2080 WEST BROADWAY (COMPLETE APPLICATION)
DE412784 - ZONE C3-A

DEVELOPMENT PERMIT STAFF COMMITTEE MEMBERS

EXECUTIVE SUMMARY

- **Proposal:** To develop this site with a seven storey mixed-use building containing retail and residential uses (a total of 135 dwelling units) all over three levels of underground parking having vehicular access from the lane.

LEVEL 1

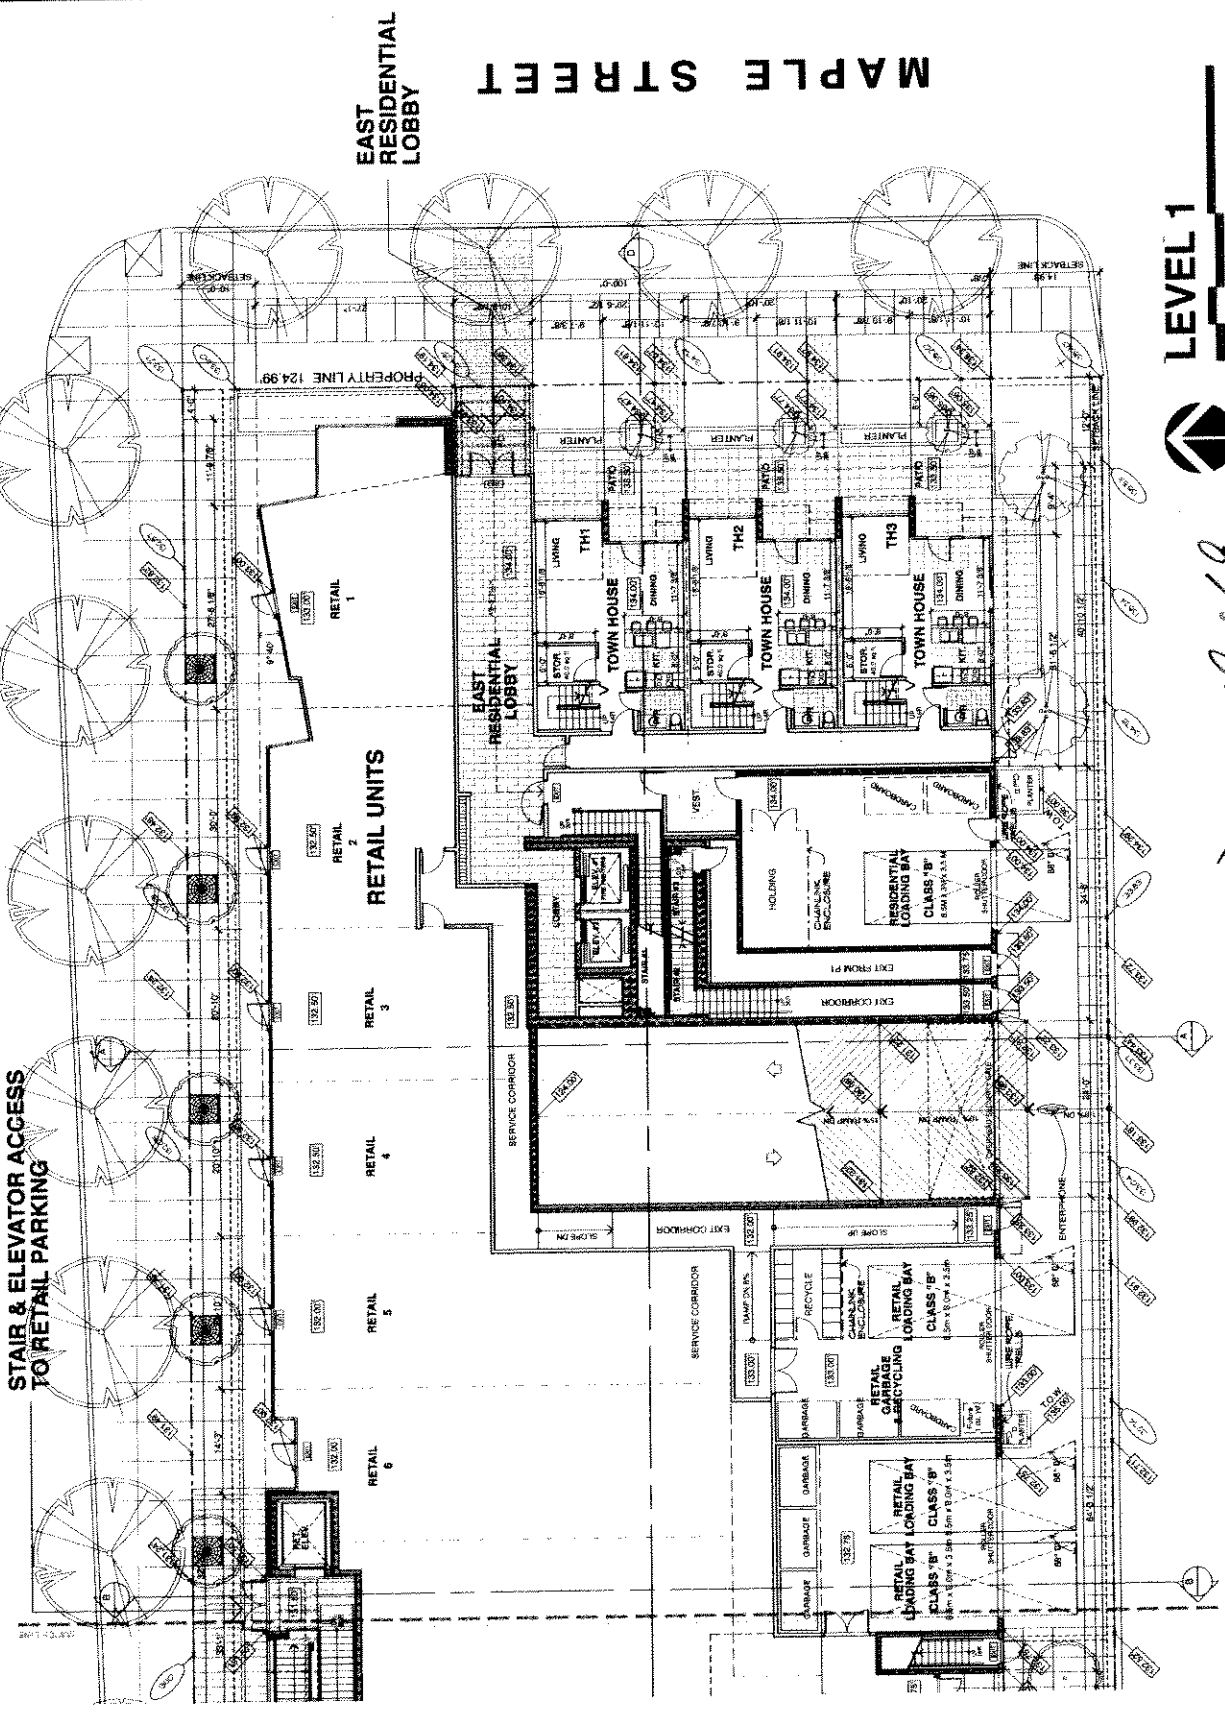
Another concern is the retail unit at the corner and its frontage along Maple Street. Staff would recommend increasing the amount of glazed frontage to give a stronger corner presence and to better align with the corner retail frontage across the street at 2528 Maple Street and that the landscape planter at the corner be removed to improve visibility of the retail frontage and connection to the street. (See Condition 1.1.2)

1.1.2 increase the width of the glazed Maple Street frontage for retail unit #1 by 4 ft. (1.2 m), to approximately align with the retail frontage across the street at 2528 Maple Street and removing the landscape planter at the corner;

ROOF PLAN

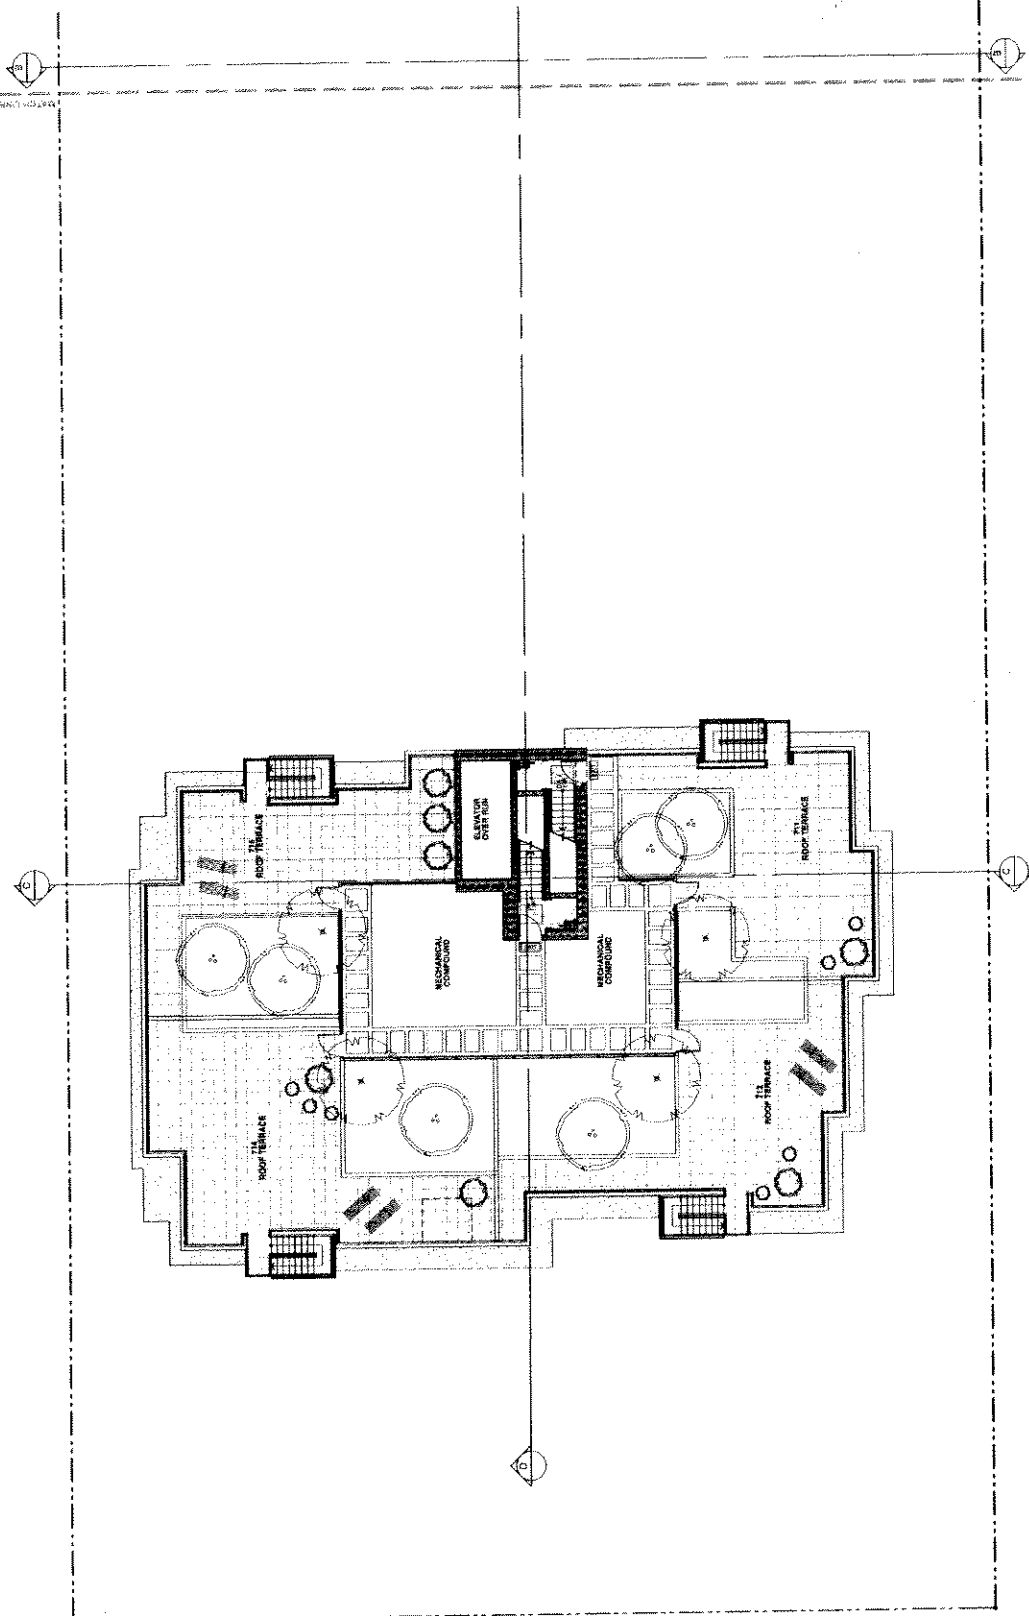
Overlook of the upper, mid and lower roof levels has been generally well handled with a mix of soft and hard landscaping that will provide a pleasant vista from adjacent buildings. On both the east and west rooftops there is a wall enclosure, screening two large roof areas identified as a “mechanical

compound". Staff consider the enclosed areas to be excessively large, compromising overlook and a potential view obstruction. Staff recommend that this area be substantially reduced and the mechanical units identified on the plan. (See Condition 1.10)

Note to Applicant: Substantially reduce the area of the mechanical enclosures, locating and identifying the proposed mechanical units within the enclosure on the roof plan. The enclosure screening should be attractive and well integrated with the architecture.
